FOR PERCOLATION TESTING AND SITE EVALUATION

RE: Perc Cert_Fairlane Farms_Lot 30

Via:	Fax	☐ Mail		ger	E-Mail	☐ To Be Picked Up
	Fax (ori	ginal to follow via U.S.	Mail)			
To:	Bureau of E	Environmental He	alth		Attn: Ha	nnk
	8930 Stanfo	ord Blvd.			Fax:	
	Columbia,	Maryland 21046-4	4544		Phone: 41	10-313-2640
From:	Tony Fertit	ta			CC:	
Re:	Fairlane Fa	rms, Lot 30			W.O.# 05	106-3003
Date:	July 3, 2019	9			Pages: 0	Page(s) Including this cover
We a	re forwarding:	☐ Prints ☐ Co	py of Letter	Spe	cifications	☐ Shop drawings ☐ Other
		Urgent Fo	r your use	As re	equested	
Rema	arks:					
Re:	Fairlane Farn	n, Lot 30, 15204 To	orino Way.			
		of the revised per any questions.	c cert plan	for Lot 3	0 for your	review/approval Please let me
Than	ık You,					
Tony	.					
Fishe	er, Collins, &	Carter, Inc. Ph. 4	10-461-285	5

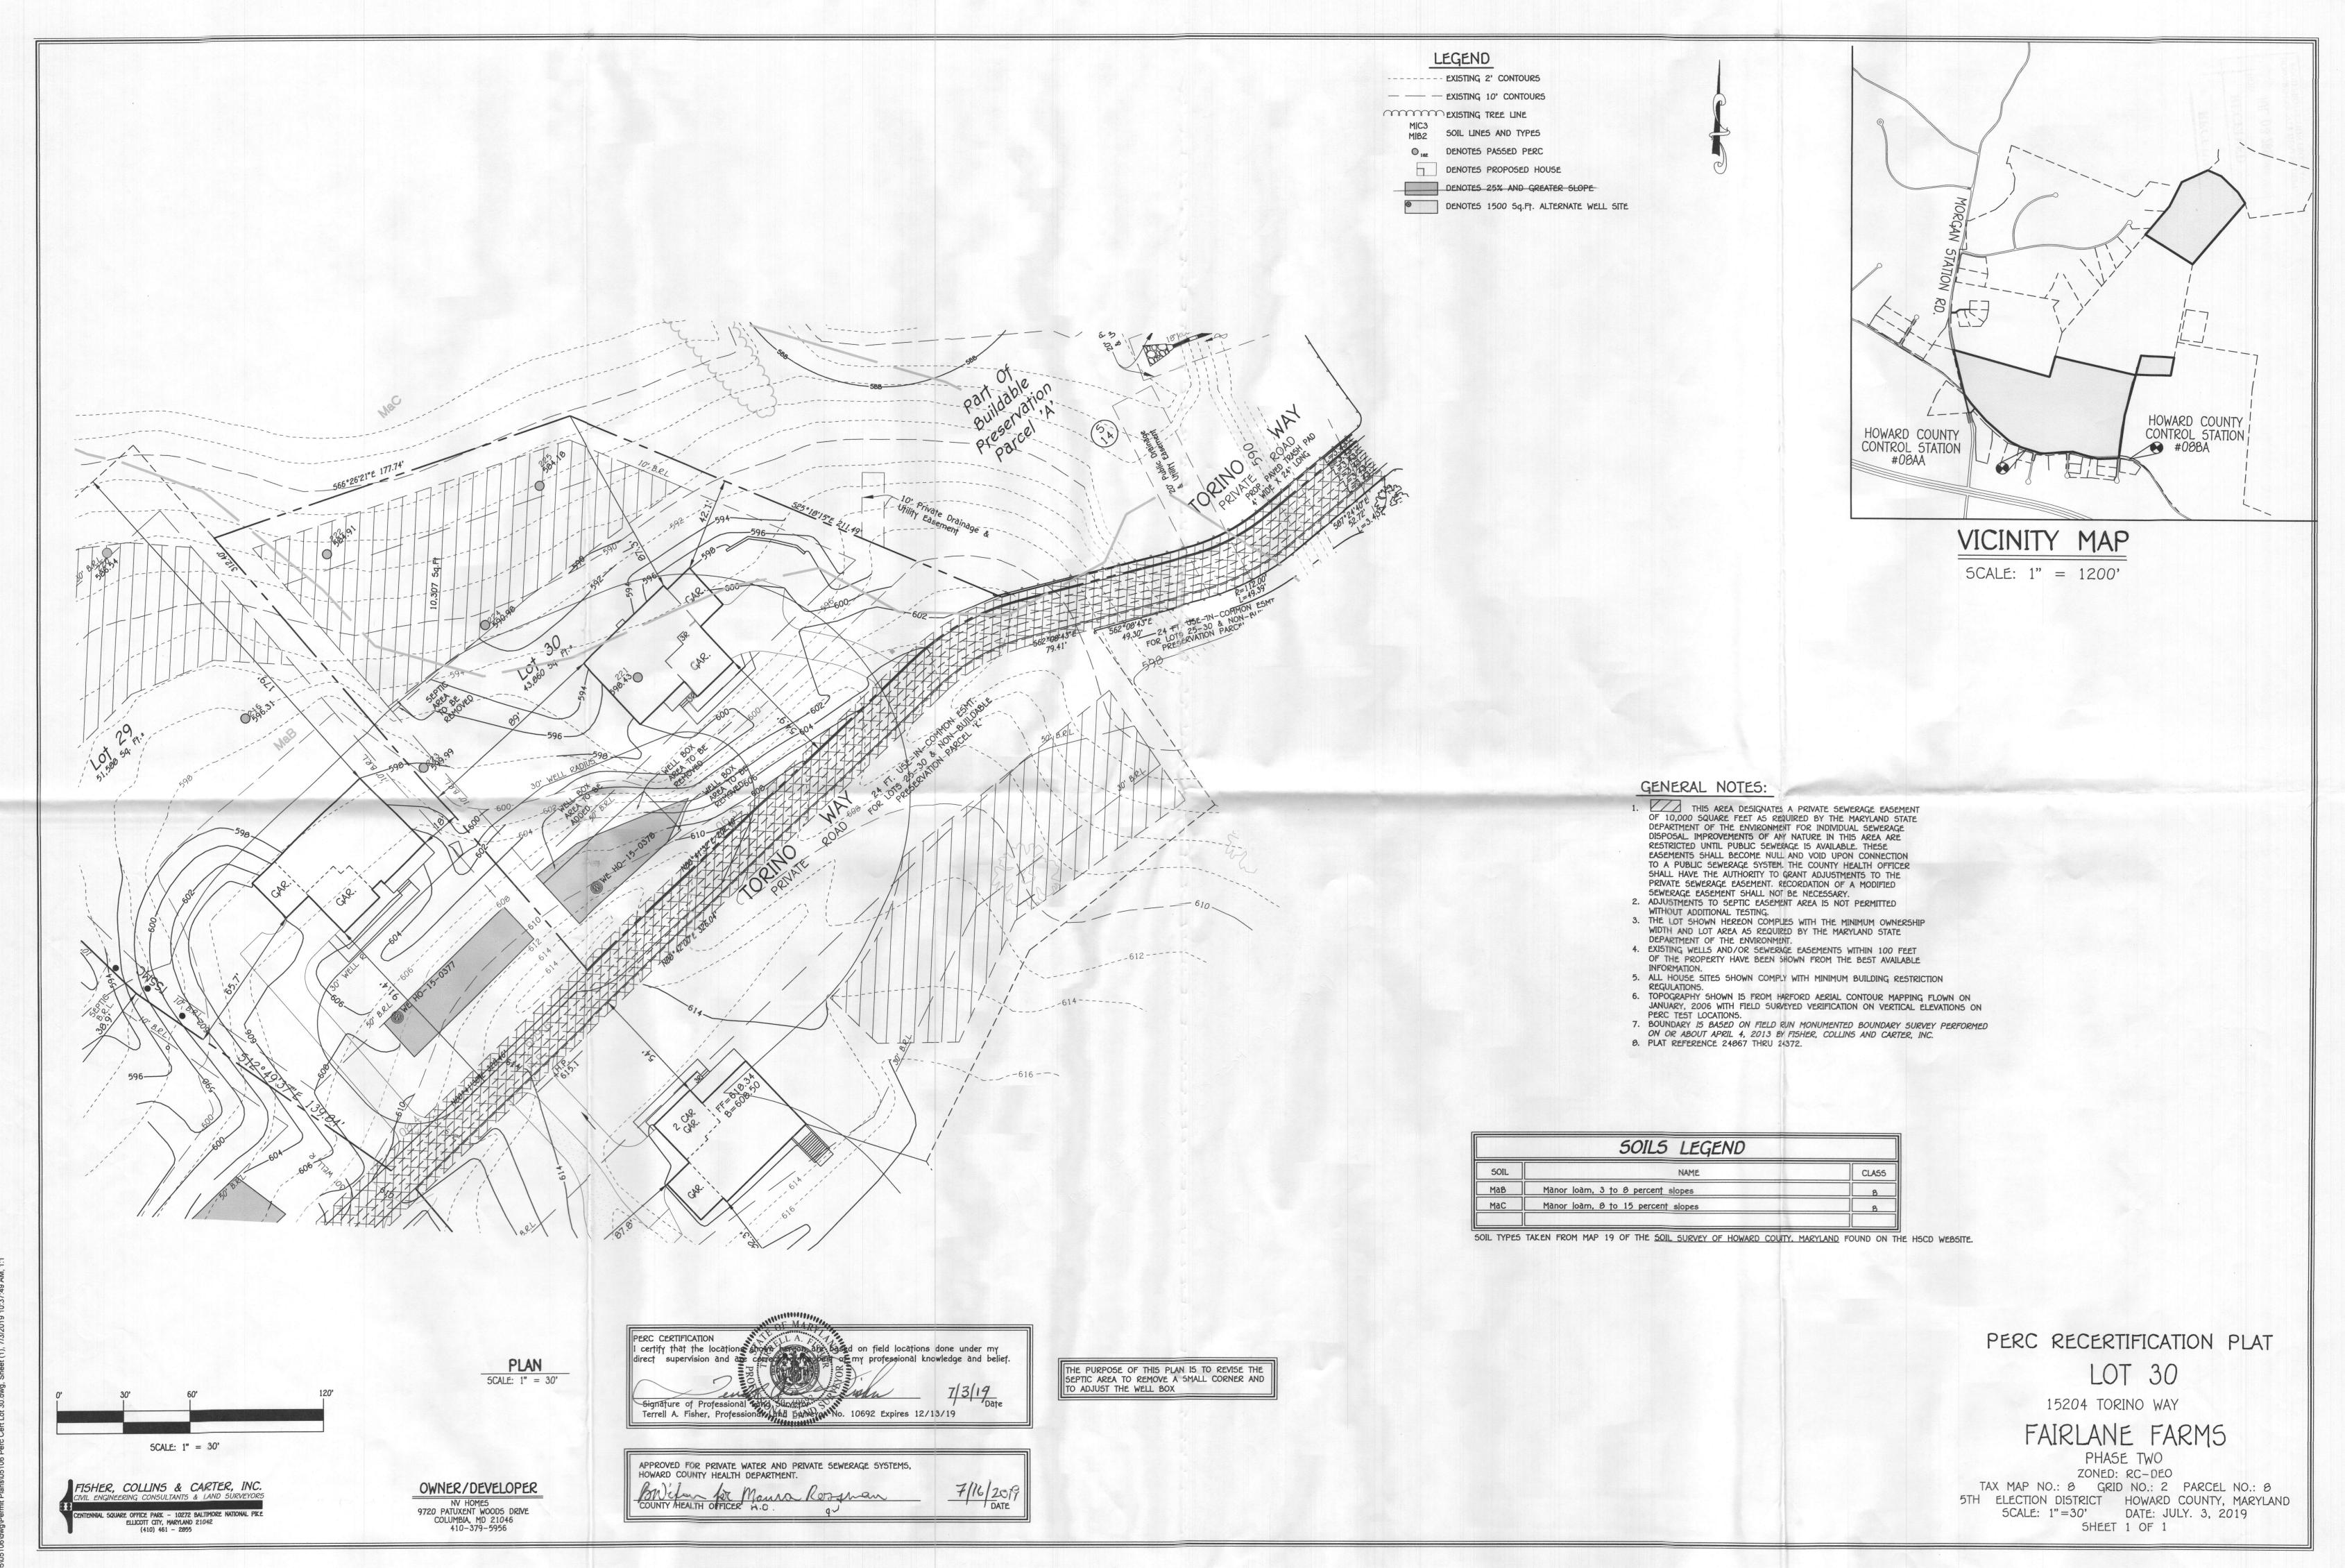
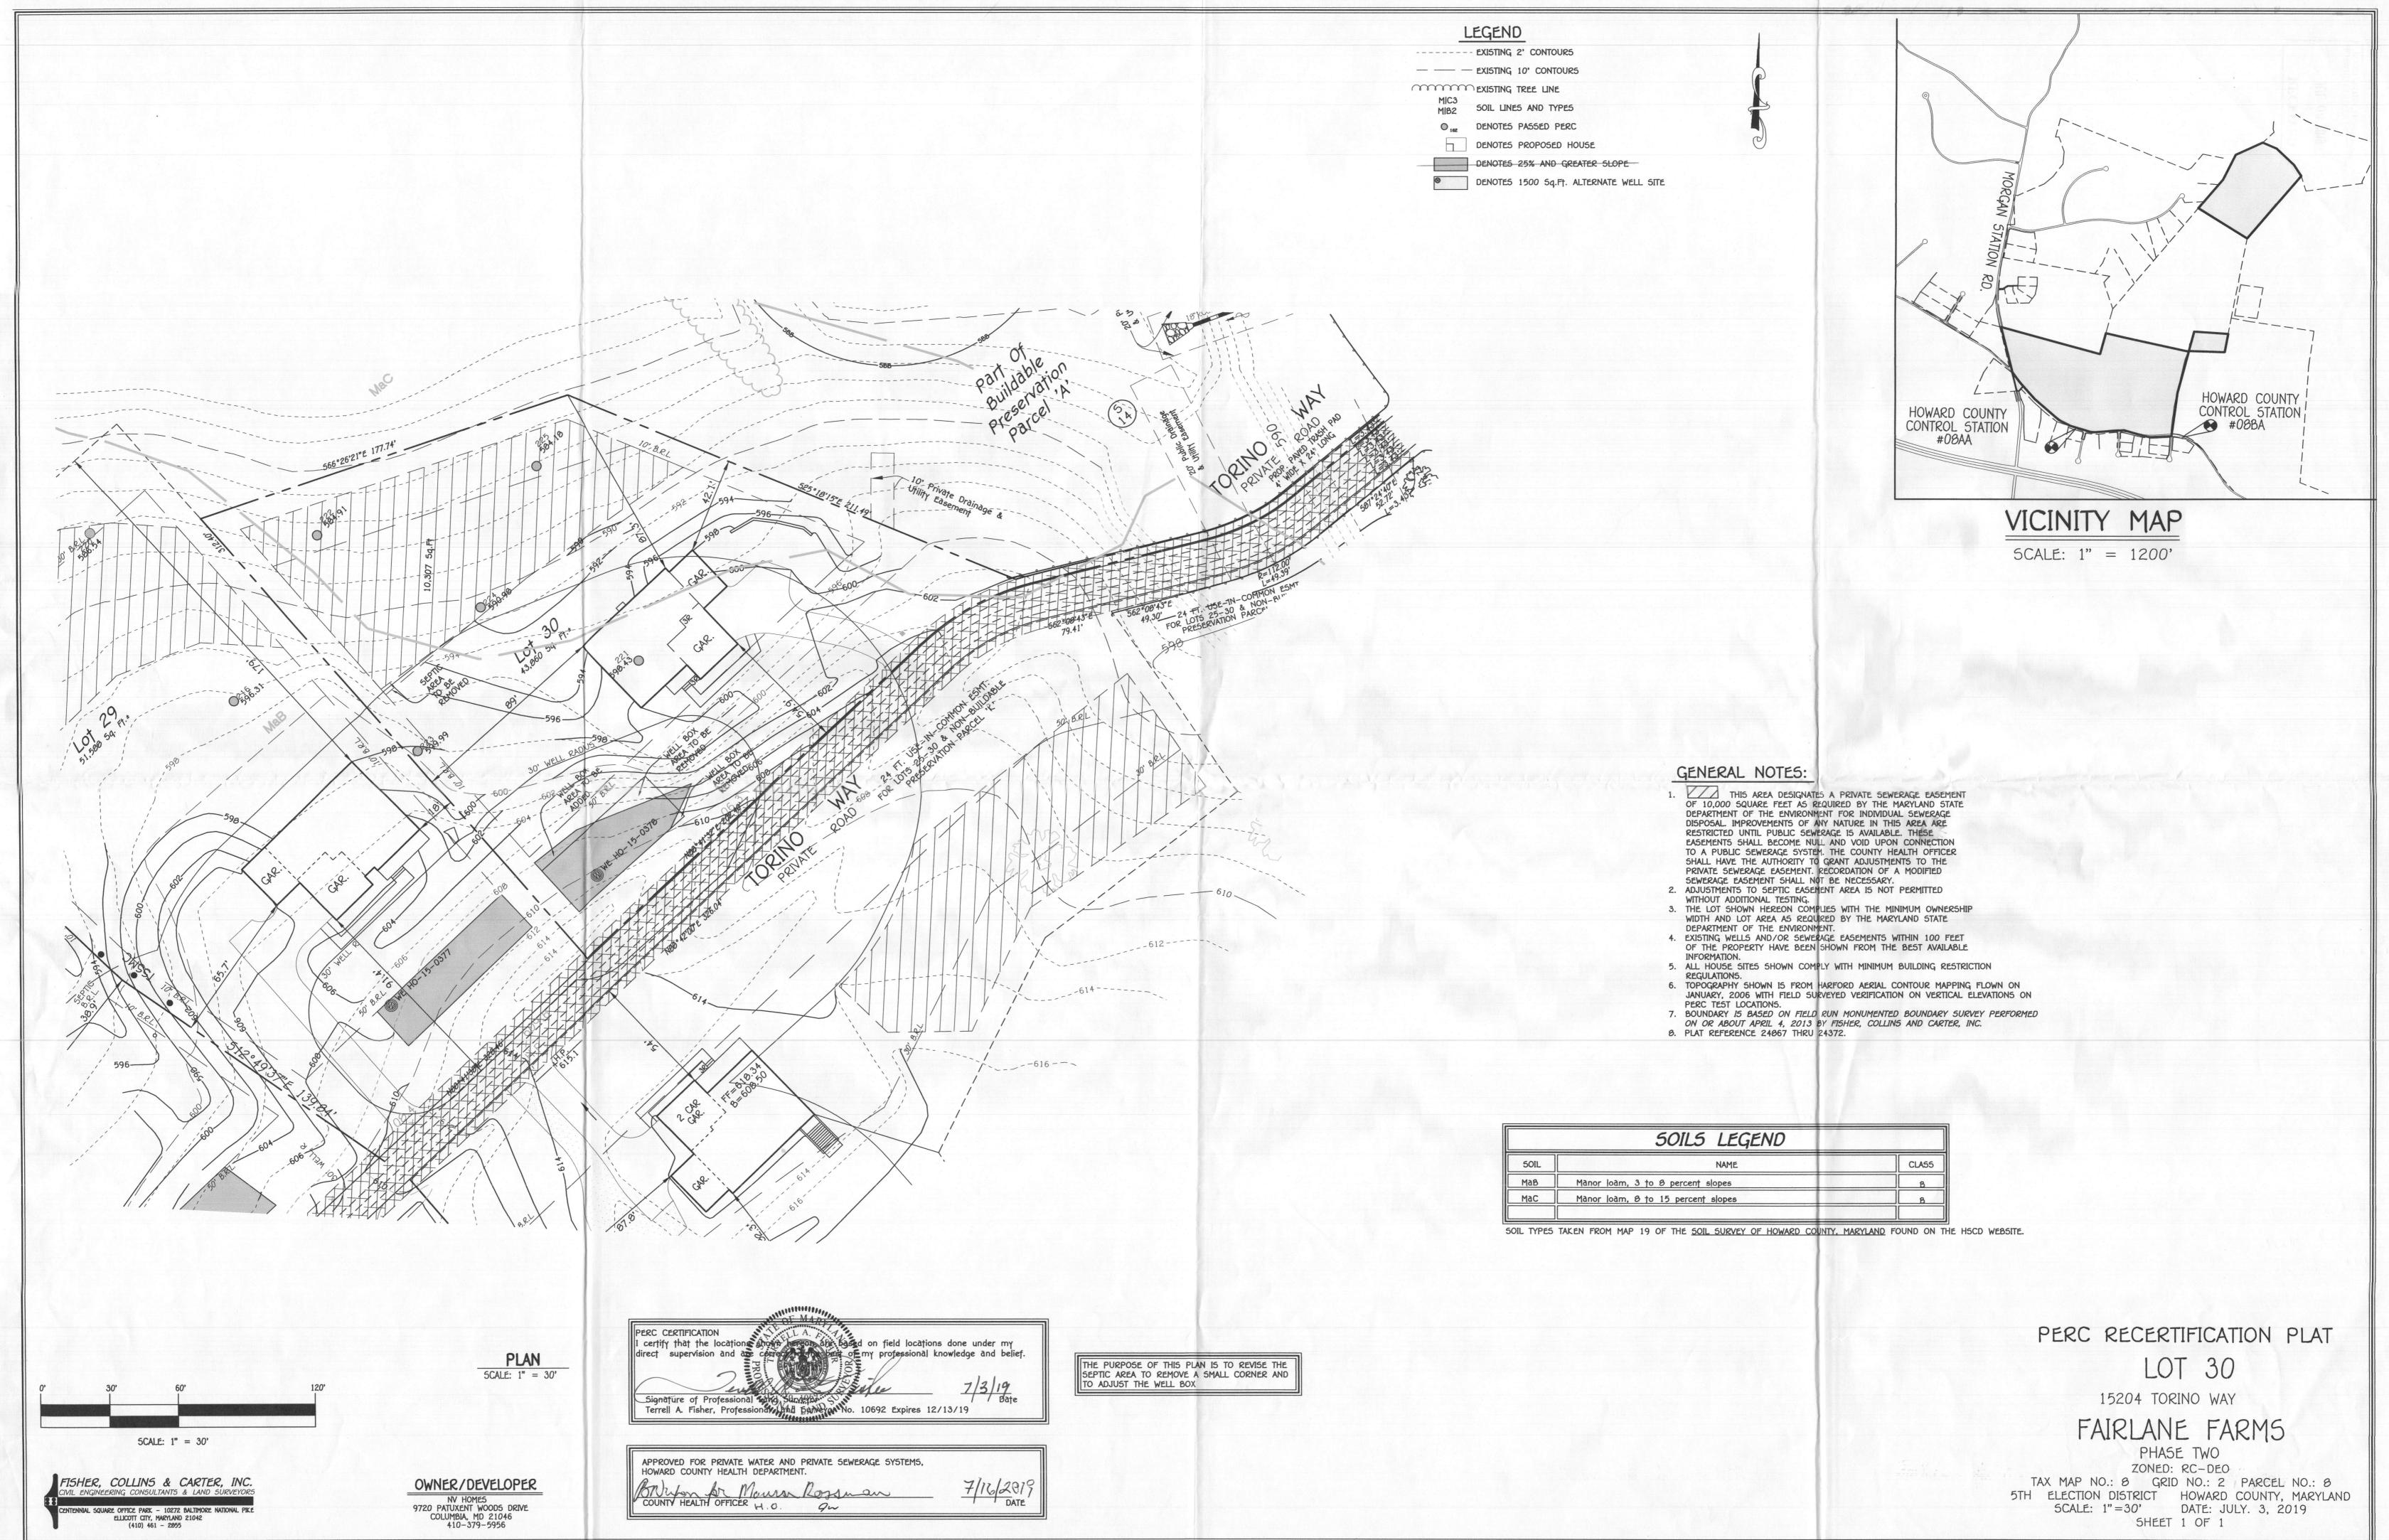
I am reviewing the perc recert plan for Fairlane Farms, Lot 30 and I had a question about note #6. It reads, Topo shown is from Harford Aerial Contour Mapping etc. Why Harford and not Howard? Also, you have a symbol in the legend for steep slopes but not showing any on the plan. I could strike a line through it. In addition, you don't have a field location note for the existing well. Lastly, there is no arrow pointing to the well box to be added at the tip of it. I could submit as is, but it might bounce back.

WE HAD A COMPANY FLY THE SIT FOR THE TOPO . YOU CAN STRIKE A LINE THROUGH THE STEEP SLOPES THEN SEND IT UP SEE WHT THY SAY. THANKS............ SORRY ABOUT CAPS JUST NOTICED.
